RIVERMONT PRECINCT 2
STAGE 1 - 17 LOTS

DRAWING INDEX

PLANS AND DOCUMENTS
referred to in the PDA
DEVELOPMENT APPROVAL

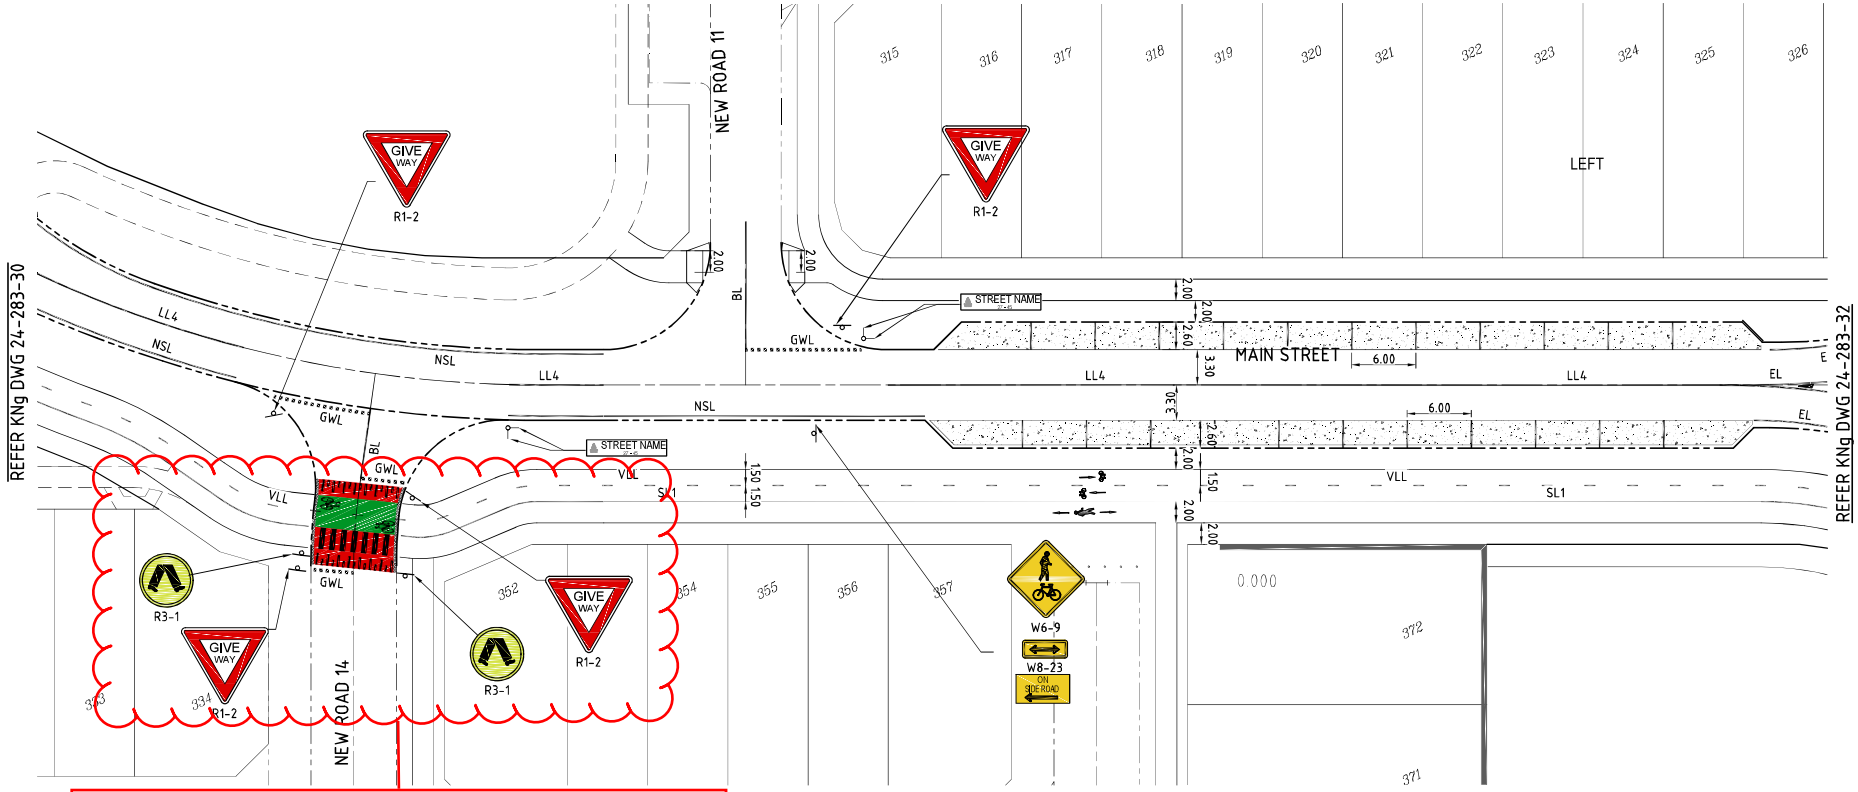
Refer to signage and linemarking condition.

Drawing Title: ROADWORKS SIGNS AND LINEMARKING PLAN SHEET 3

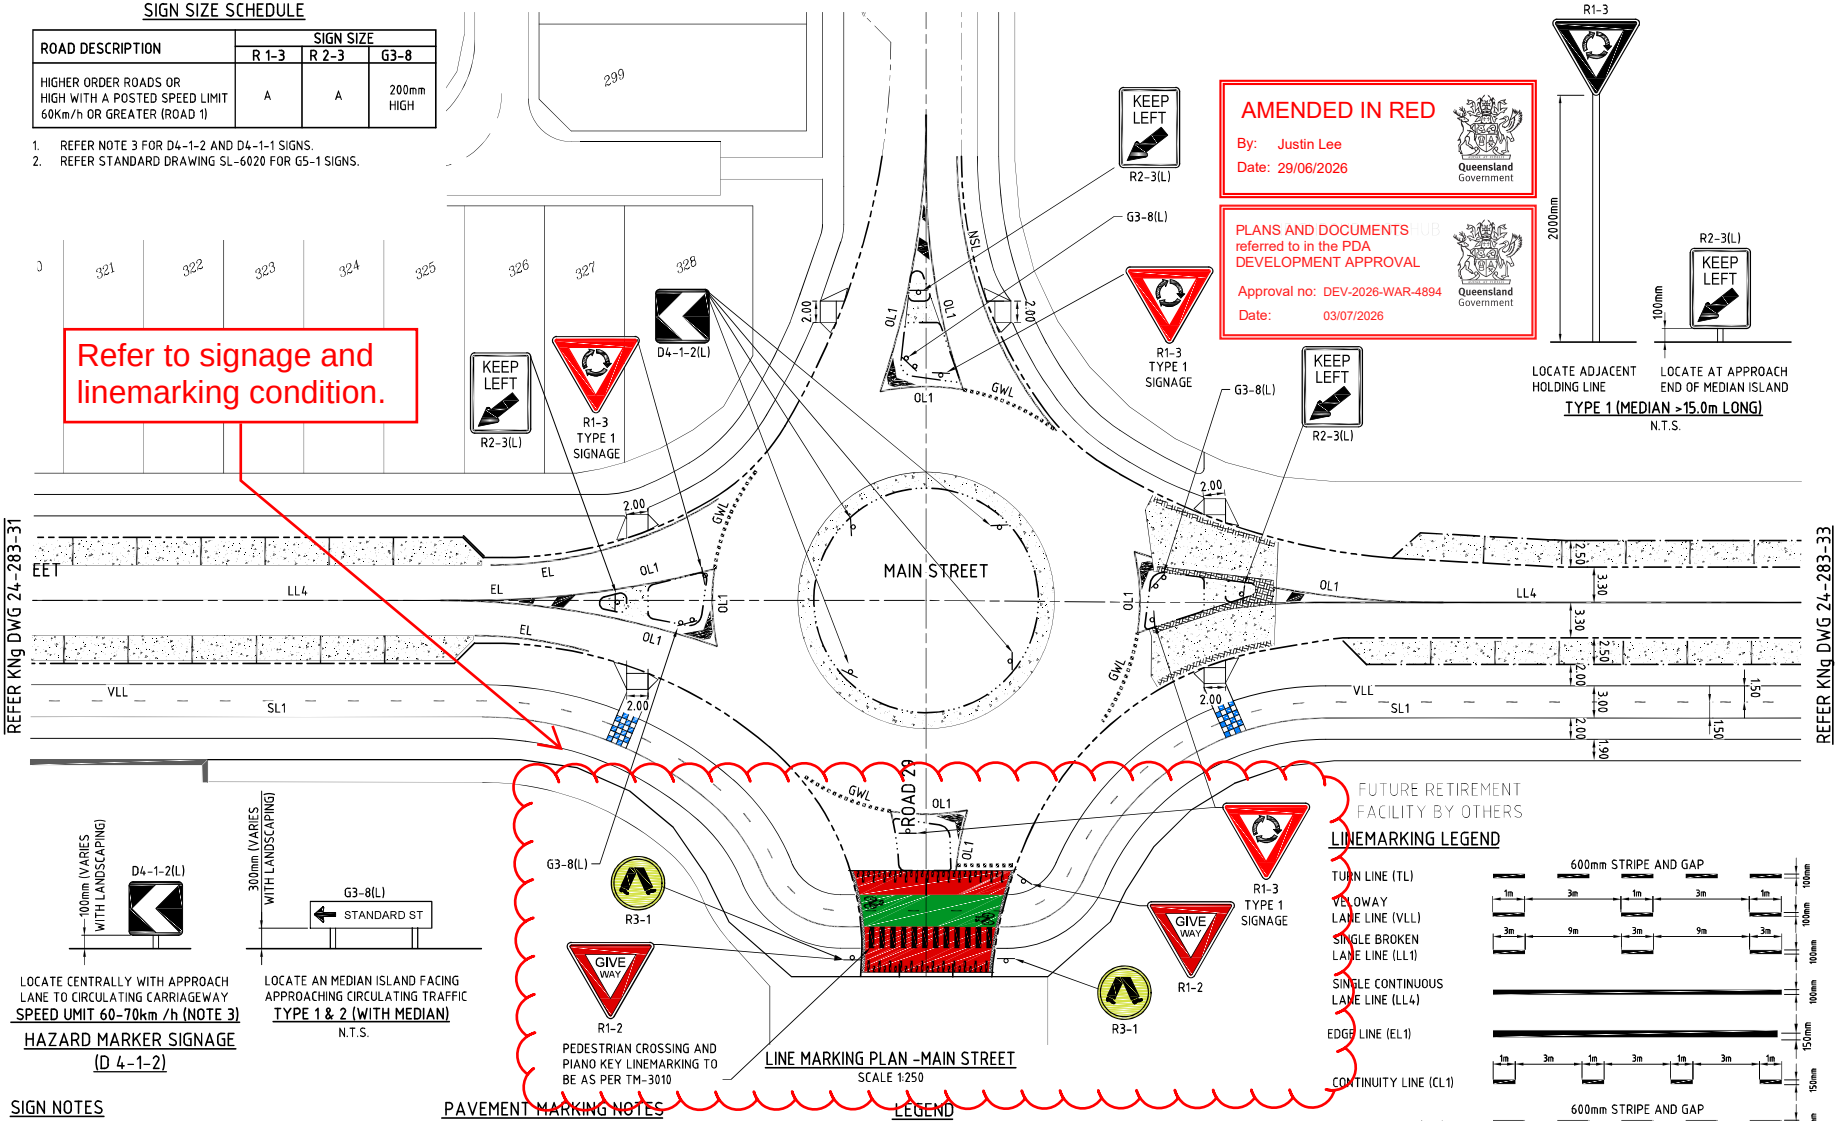
Refer to signage and linemarking condition.

Drawing Title: STORMWATER LONGITUDINAL SECTION SHEET 1

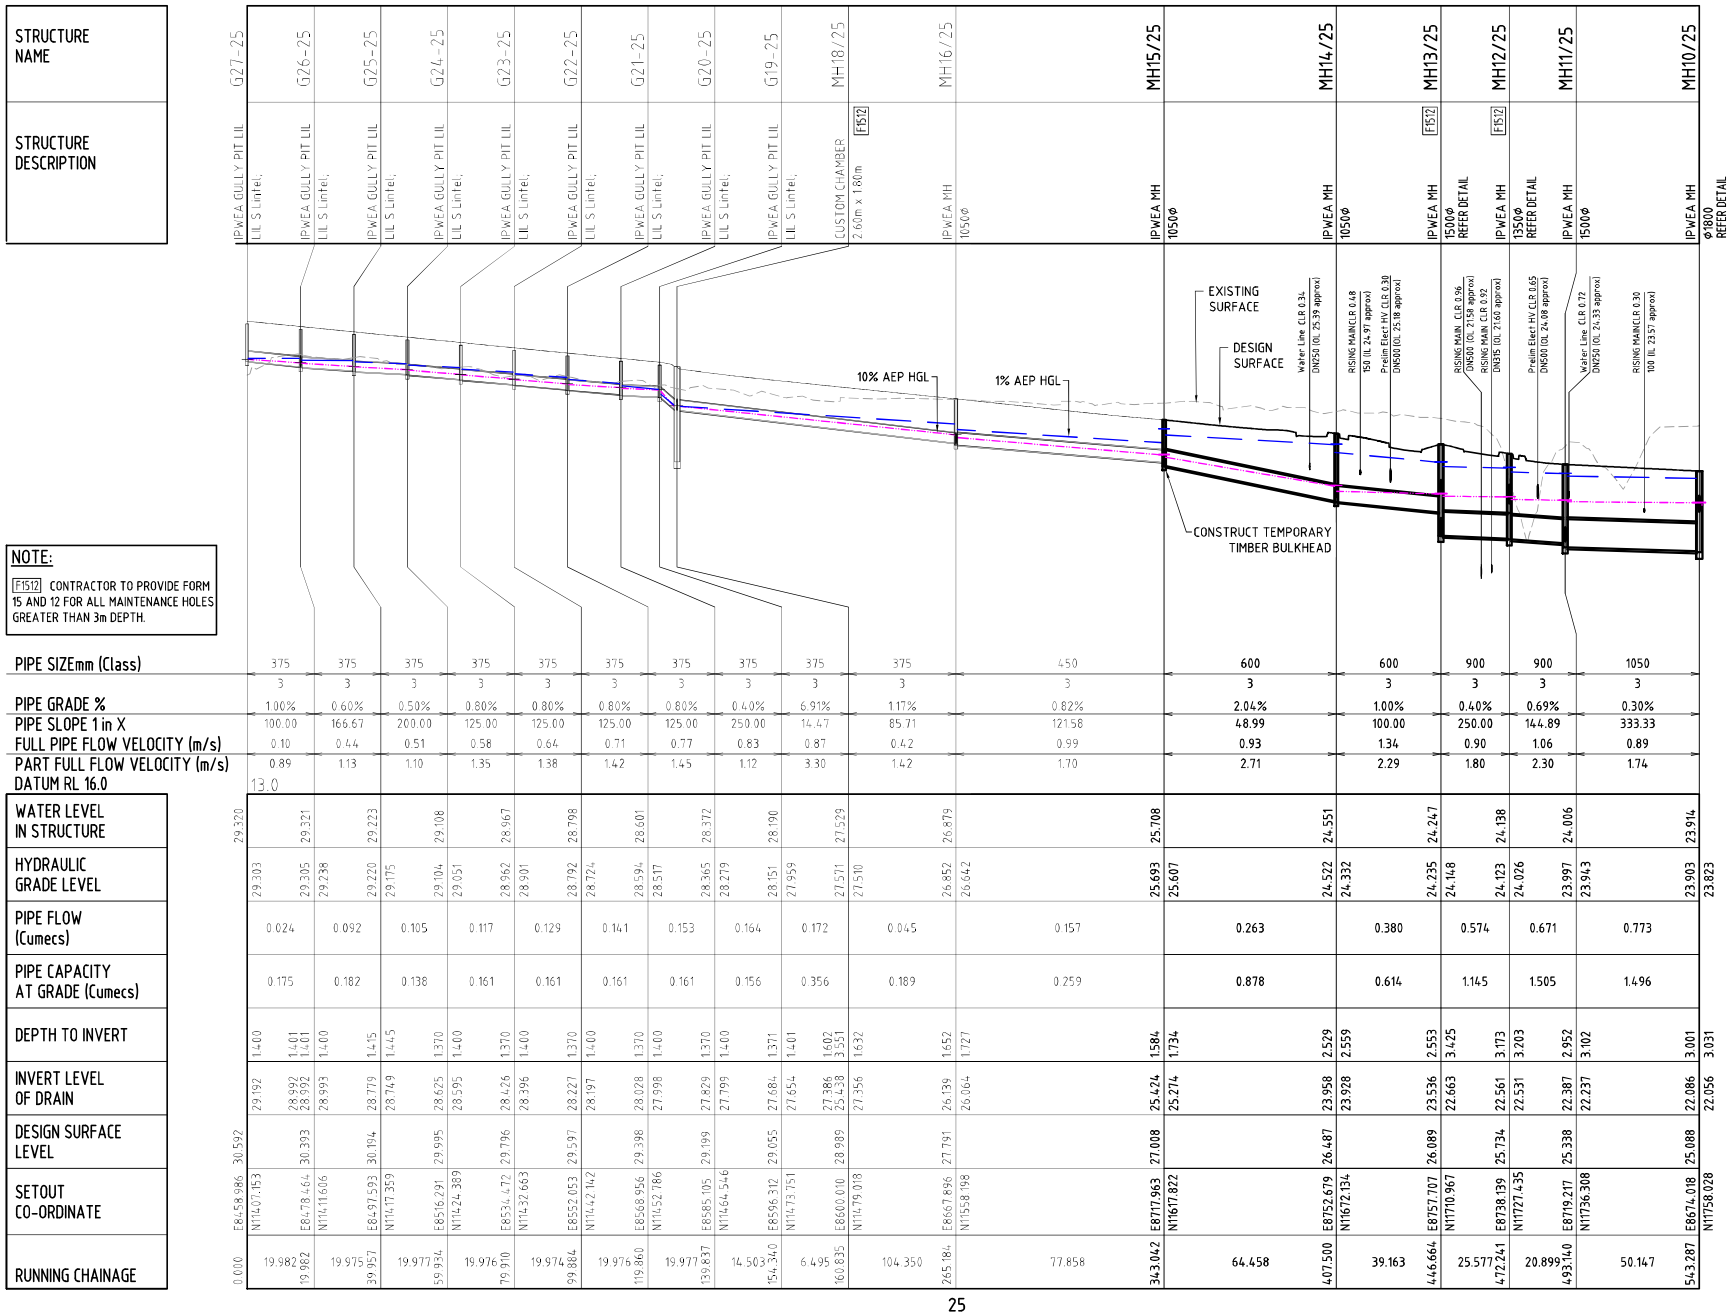
Does not form part of this approval.

Drawing Title
STORMWATER LONGITUDINAL SECTION SHEET 2

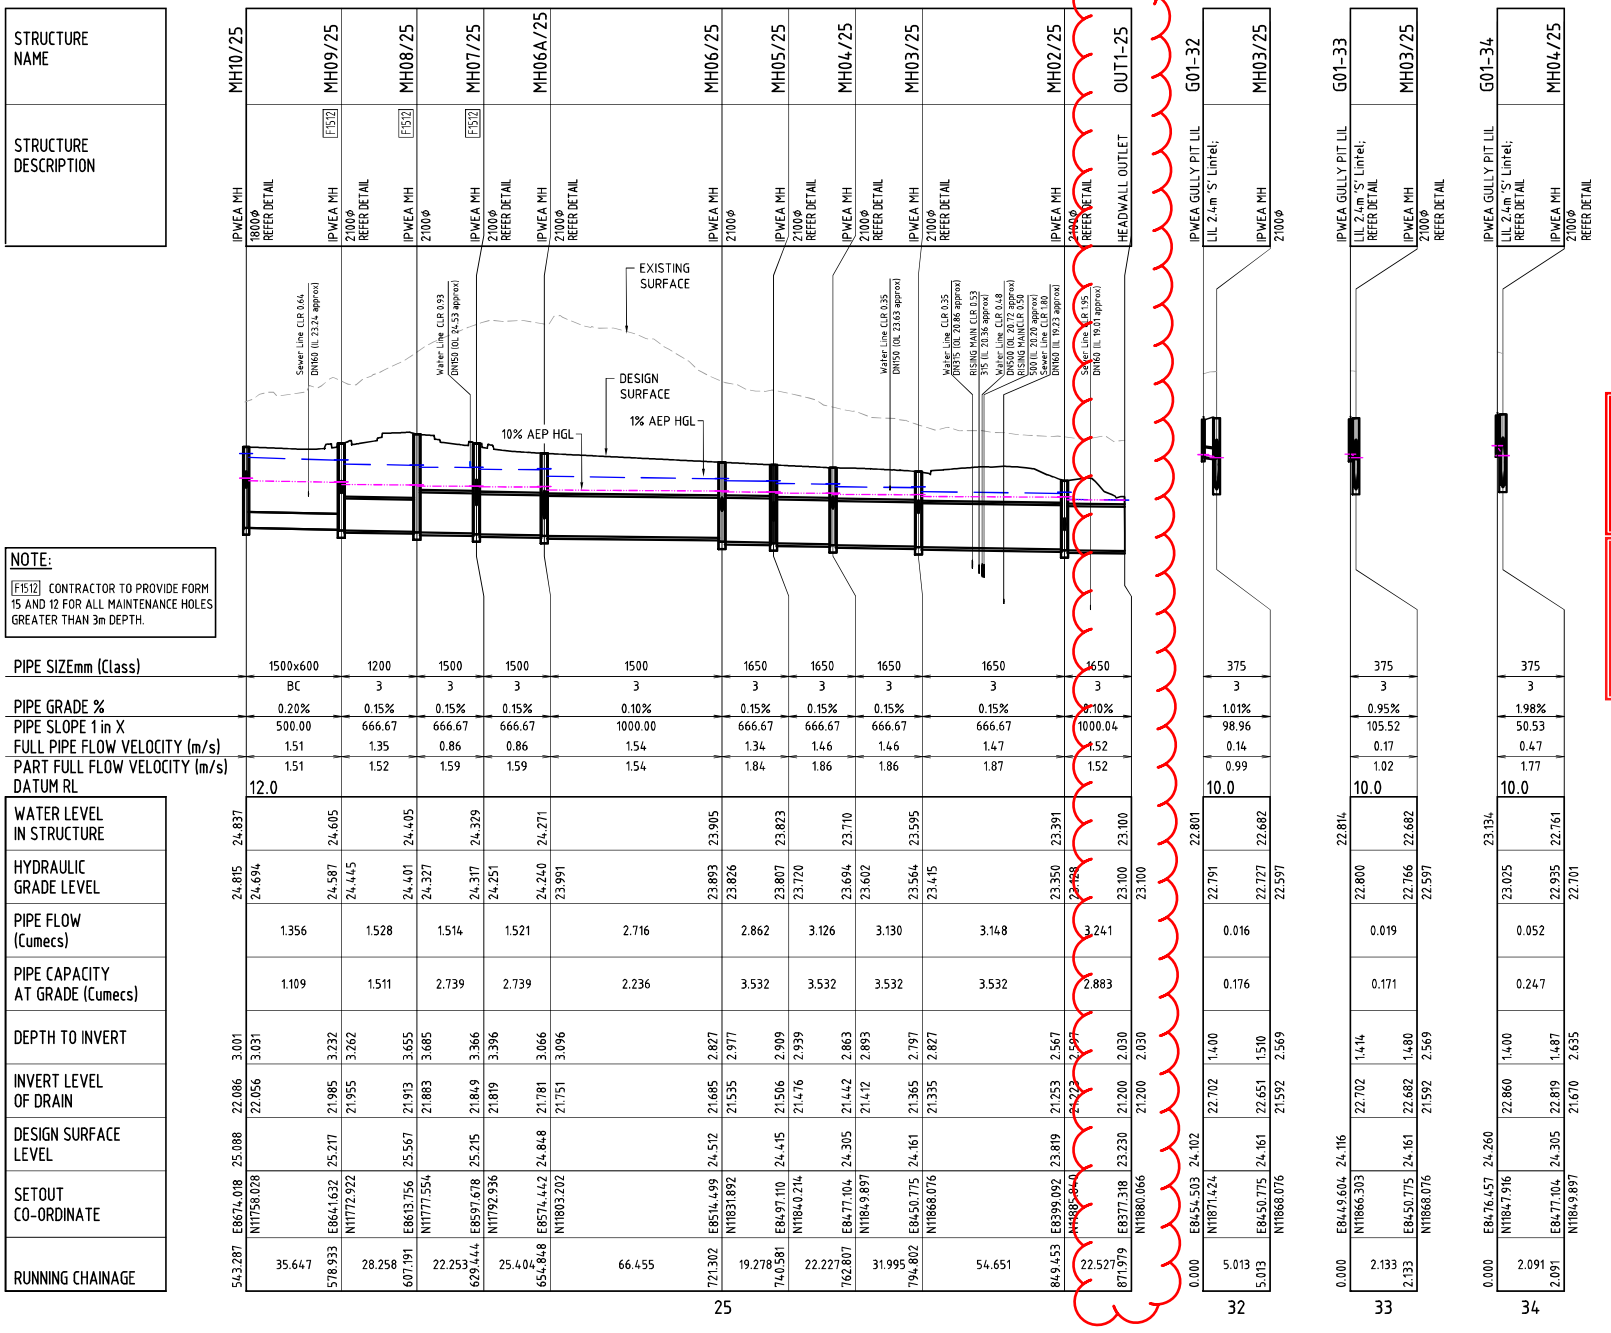
Gully Pit G01-43 to be confirmed as part of separate application.

MANHOLE MH13/25- Ø1350
SCALE 1:25

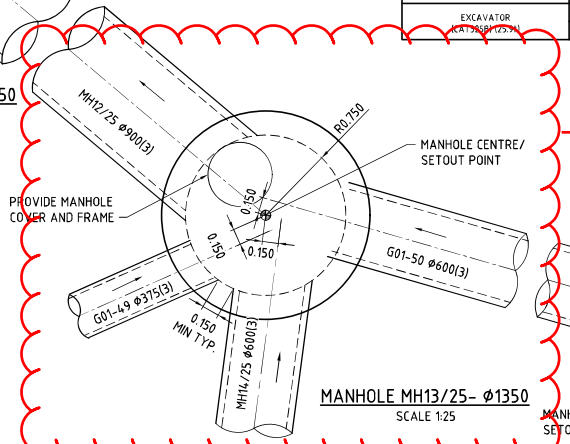
Structure MH13/25 to be constructed with a 1500mm diameter manhole chamber to be RPEQ designed and certified as per IPWEA Standard Drawing DS-010 Note 6.
